North Wambo Underground Mine Longwall 10A Modification

Groundwater Assessment -
Responses to NSW Office of Water Concerns

Project number: WAM009

Report: HC2015/010

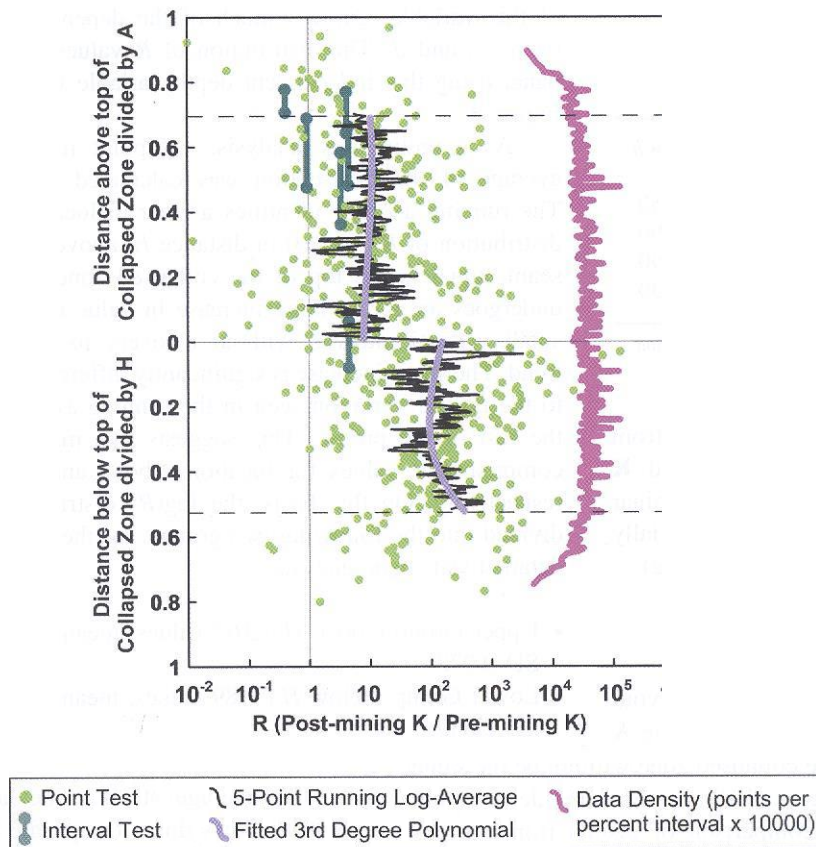
The NOW Attachment A (February 2015) stated: "The Kz max values applied in the model are constrained to very low values as not to be consistent with the textural description of the A fracture zone."

A very recent paper by Tammetta (2015)³ shows that *in situ* permeability enhancement in a fractured zone is only a factor (R) of 100 or so (± 1 order of magnitude); reproduced below.

Figure 1. Ramp functions applied in the Wambo regional groundwater model [a] Calibration model; [b] Extreme model

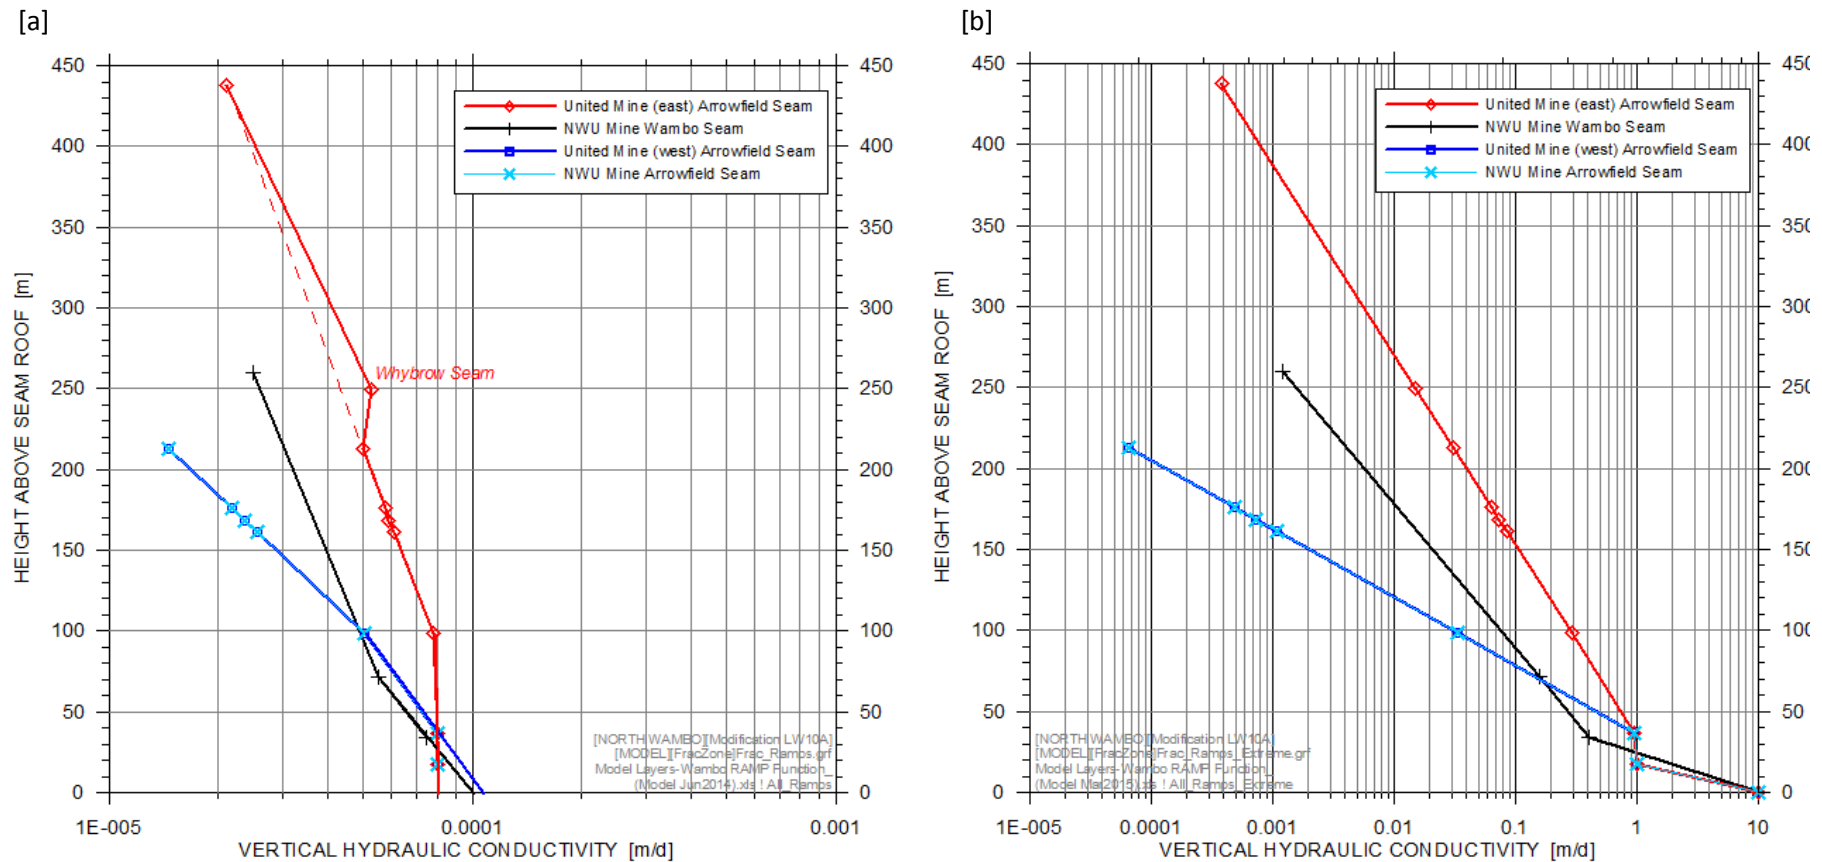
The NOW is of the view that fractured zone hydraulic conductivities in the order of 1 m/day are appropriate, and cited one instance of adoption of this value for the Russell Vale Colliery model. However, the same model has instances of maximum values of 1×10^{-6} to 3×10^{-4} m/d for different mined seams. The values adopted in the Wambo model are constrained by calibration to very low observed mine inflows. Such high values (about 1 m/day) are inadmissible.

Nevertheless, a model has been prepared with 1 m/day as the maximum value in each fractured zone. The ramp functions for the Calibrated Model and the Extreme Model are illustrated in **Figure 1**.

The Calibrated model has a maximum R-multiplier of 73, consistent with the Tammetta database, while the Extreme model has a maximum R-multiplier of 909,000.

Figure 3. Recovery hydrographs at synthetic monitoring bore LW10A [a] Calibration model; [b] Extreme model

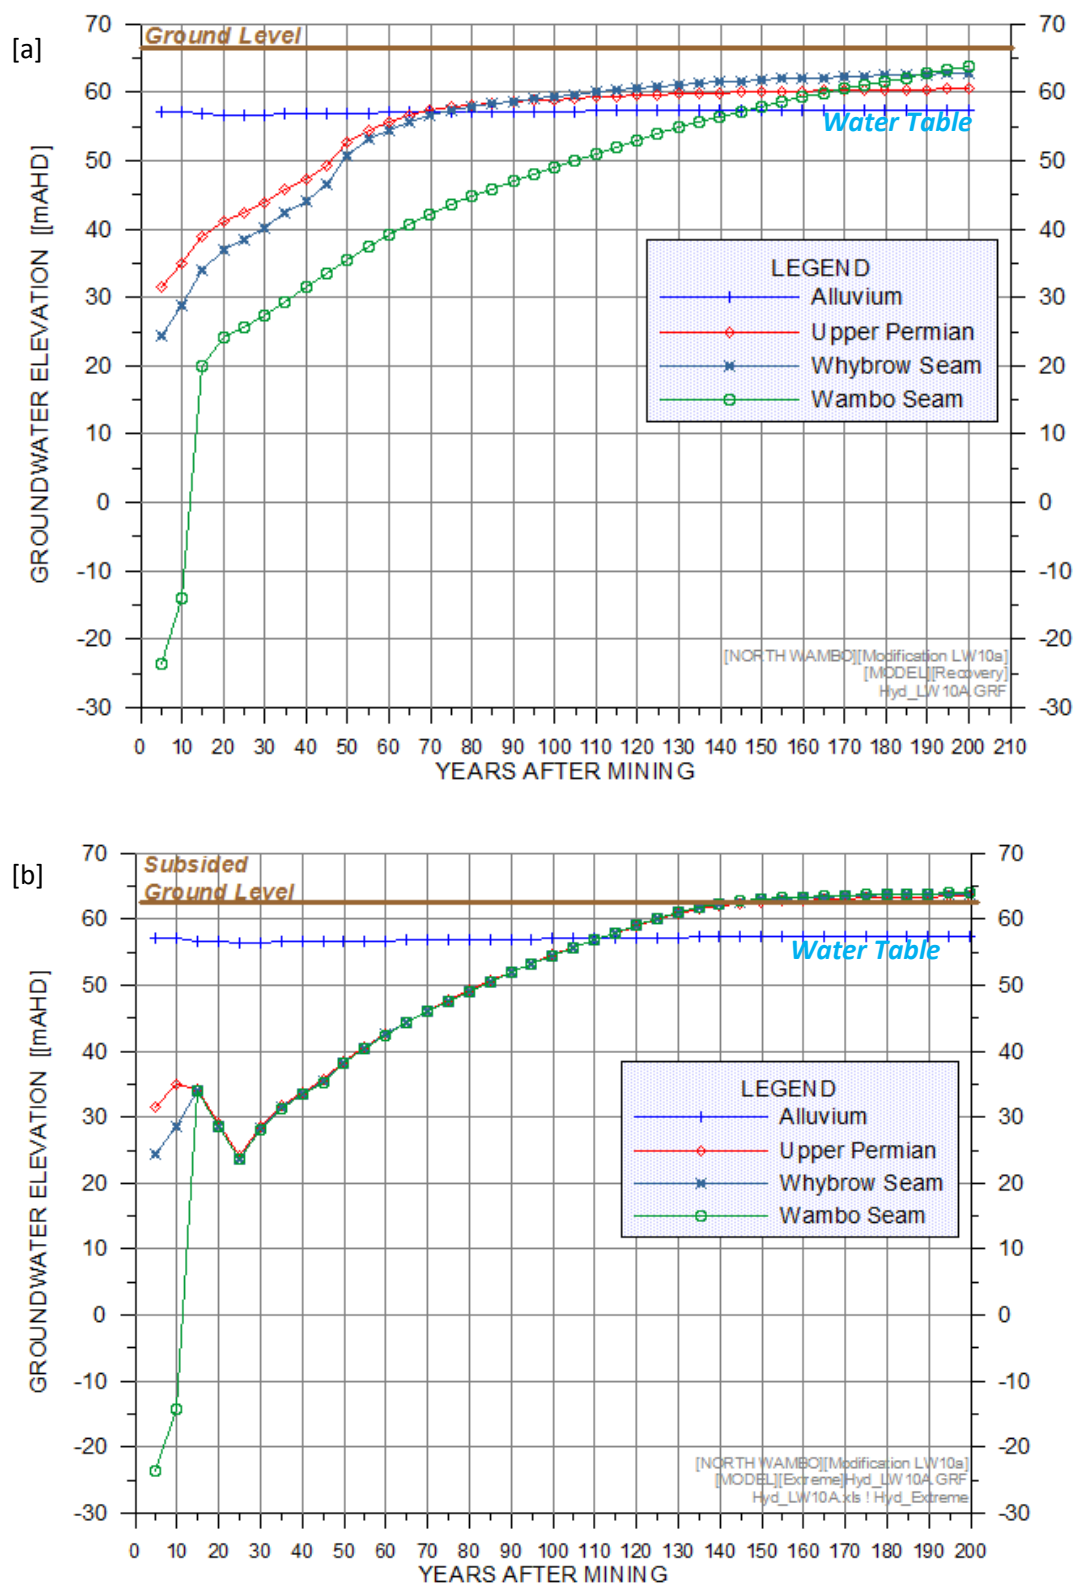
To examine the timing of upflow from Permian strata to alluvium, which could create a water quality impact, a synthetic monitoring bore has been placed in the model at the location marked "LW10A" in **Figure 2**. The groundwater hydrographs in **Figure 3** show that upflow would be expected to

commence about 70 years after the cessation of mining for the Calibrated model, and at about 110 years for the Extreme model.

It is noted that the three Permian hydrographs coalesce 15 years after mining finishes, due to the assumed very high vertical connectivity between the strata.

For the Calibrated model, all heads remain below the current ground level. For the Extreme model, the Permian heads are marginally artesian (above the subsided ground level), but the water table in the alluvium remains about 5 m below the subsided ground level at this location. This means that there would be no surface expression of the water table at this location.
